Item 10.**Section 4.55 Application: 888 Bourke Street, Zetland – D/2017/1723/A**

File No.: D/2017/1723/A

Figure 24: Proposed ground floor and level 1 envelope plan. Levels 2 and 3 are similar. Approved concept building envelope outlined in blue.

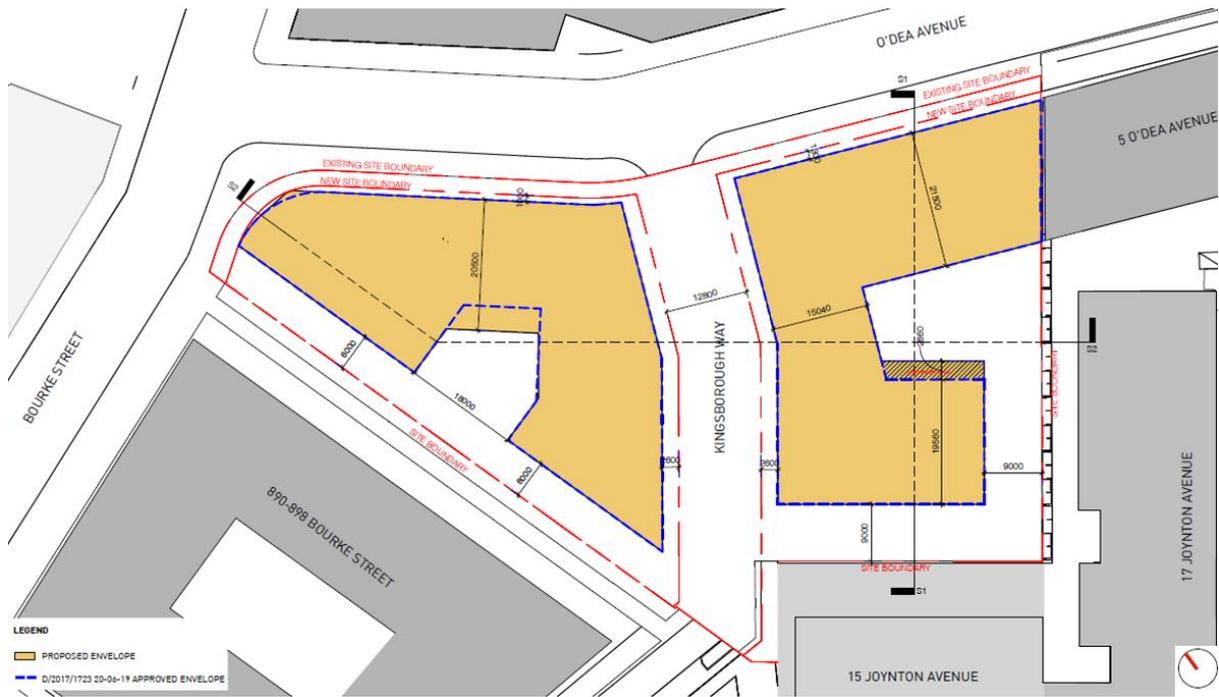
33. The Section 4.55(2) modification application seeks to modify the concept approval to bring it in line with the subsequent detailed design application.
34. The application modifies the existing concept envelope to:
 - (a) increase the height of Buildings A and B;

Figure 31: O’Dea Avenue elevation of approved concept building envelope – 22m height limit illustrated by blue dashed lines

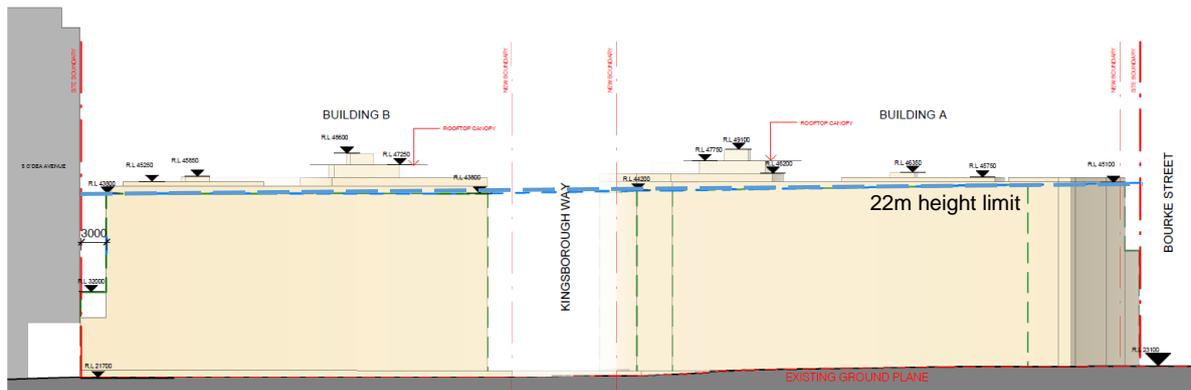
- (a) Building A – 26.74m, which represents a 4.74m or 21.5% variation; and
- (b) Building B – 26.93m, which represents a 4.93m or 22.4% variation.

56. The extent of the non-compliance is illustrated below.

Figure 34: Shadow diagrams in elevation demonstrating impact to 15 Joynton Avenue at winter solstice (9:00am, 12 midday and 3:00pm)

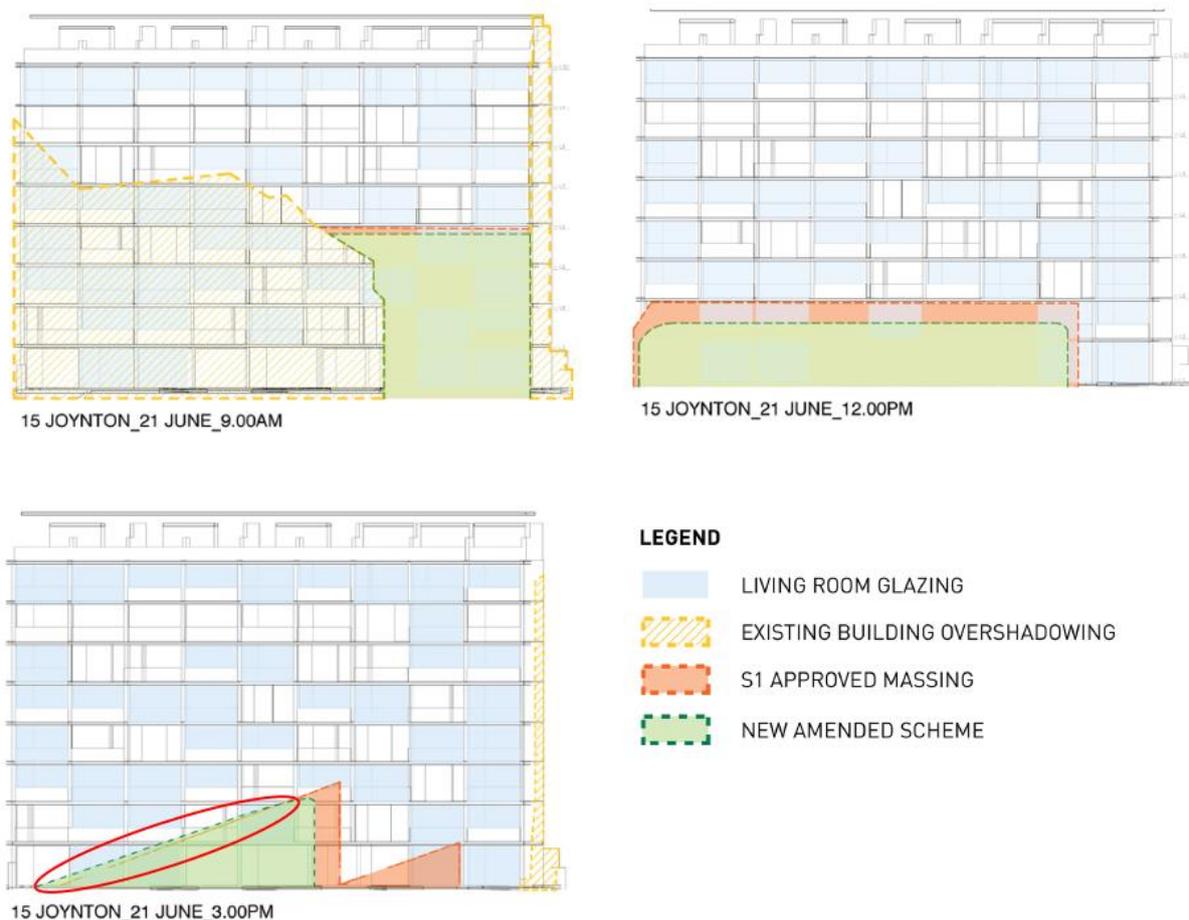
- (iv) The analysis demonstrates that 15 Joynton Avenue will experience a negligible increase in overshadowing between the hours of 1.30pm and 3pm at the winter solstice. Three apartments are affected, with one achieving 2 hours solar access, and the other two retaining 1.5 hours solar access, with a slight increase at 1.30pm. The slight increase for the two affected apartments still allows for direct sunlight as per Objective 4A-1 of the ADG.

Figure 35: Shadow diagrams in elevation demonstrating impact to 17 Joynton Avenue at winter solstice (9:00am, 12 midday and 3:00pm). Additional overshadowing outside of the originally approved envelope is outlined by the red circles.

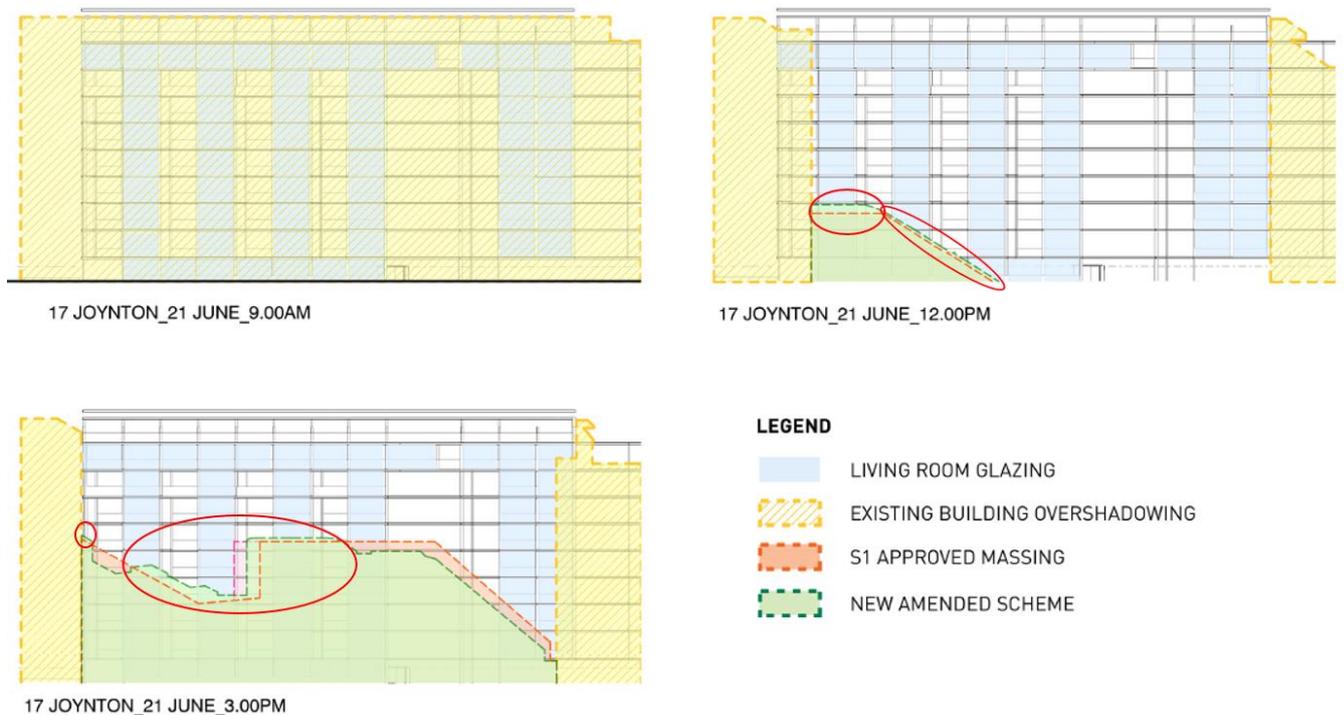
- (v) With regard to 17 Joynton Avenue, the detailed design proposal will cast additional shadow between 11.30am and 3:00pm. The overshadowing of the affected apartments shift as a result of the amended proposal. For example, the apartments at level 3 that are affected by overshadowing of the amended envelope between 2.30pm and 3pm, will receive solar access between 1.30pm and 2.00pm due to changes between the bulk of the original concept approval and the proposed detailed design.

Figure 46: Proposed concept envelope floor plan (ground to level 3) depicting increased floorplate. The approved envelope is outlined in blue.

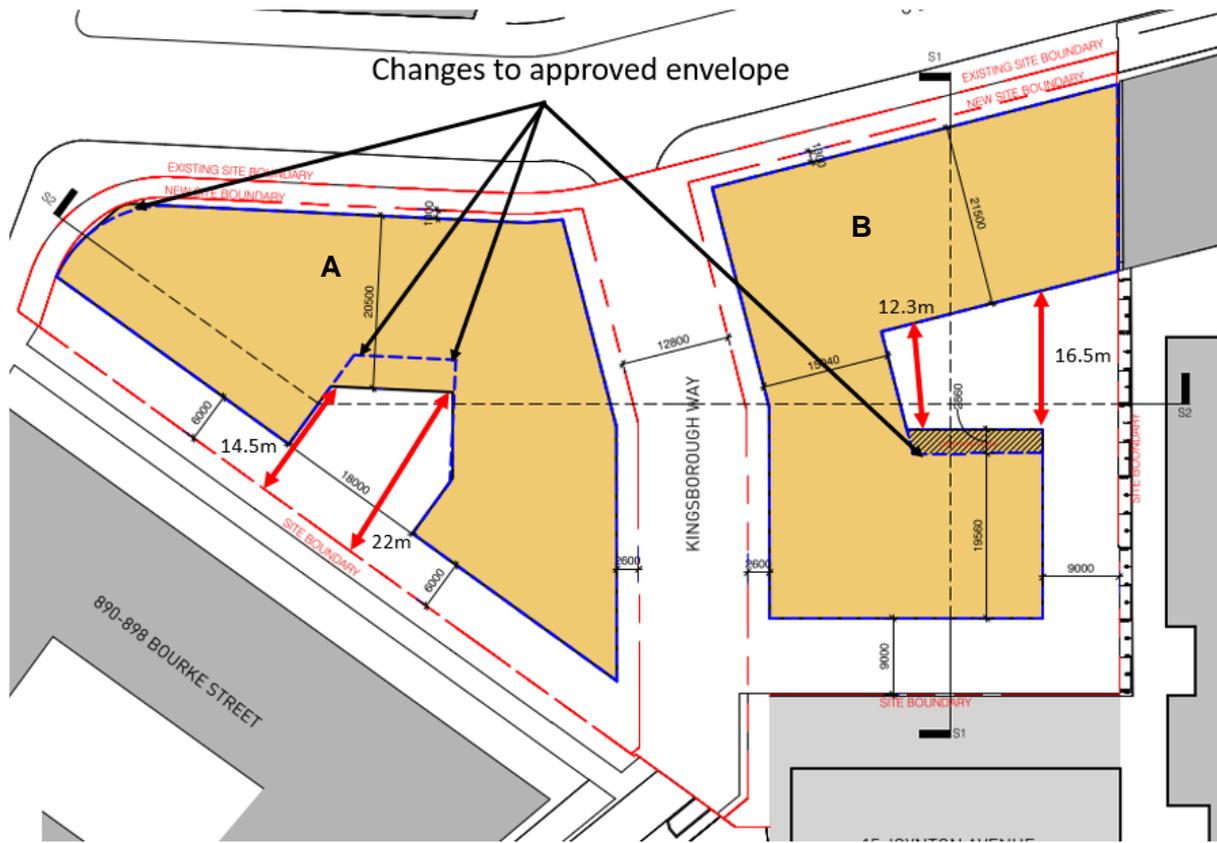
66. The proposal seeks to infill some areas of the floor plate at basement, ground and levels 1-5. The increased footprint is to be replicated at the new level 6. See floor plans below illustrating changes to the approved footprint.

68. The enlargement of the footprint facilitates a development that is consistent with the design competition winning scheme.
69. As shown in Figures 46 to 49 above, the modification increases floorplate width within Buildings A and B, however, does not alter overall separation distances to adjoining properties.
